Advisory Number: SPA-24-03-01

Dealer Advisory

ROPS Installation

Figure 3

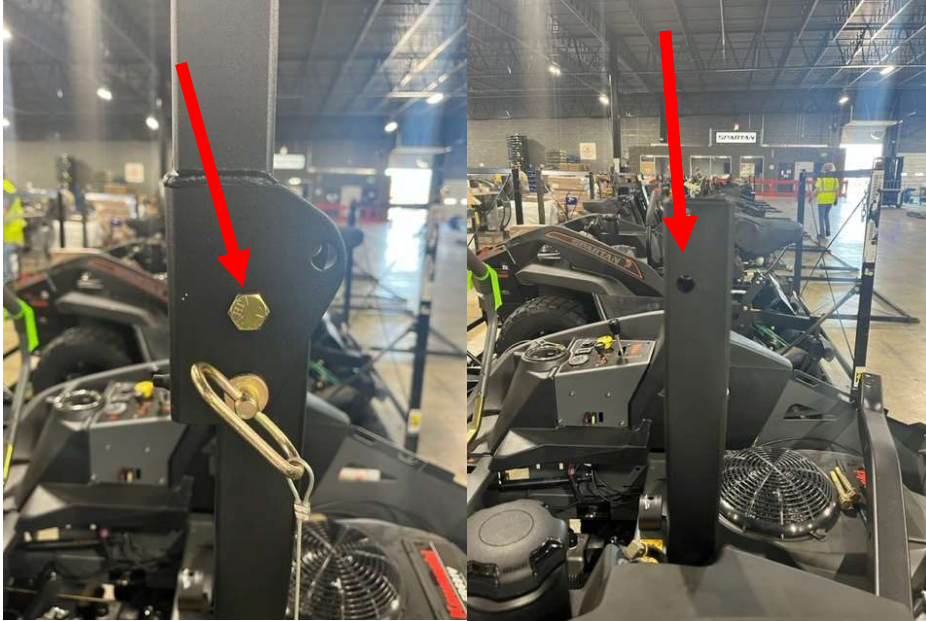
Below are pictures of ROPS that are installed incorrectly. The upper ROPS mounting holes are positioned towards the front of the mower (incorrectly). When the ROPS are folded down, the pin holes will not line up. (Figure 3)

Install the lowers ROPS brackets with the upper ROPS mounting holes positioned towards the rear of the mower, so that the folded position has proper pin hole alignment.
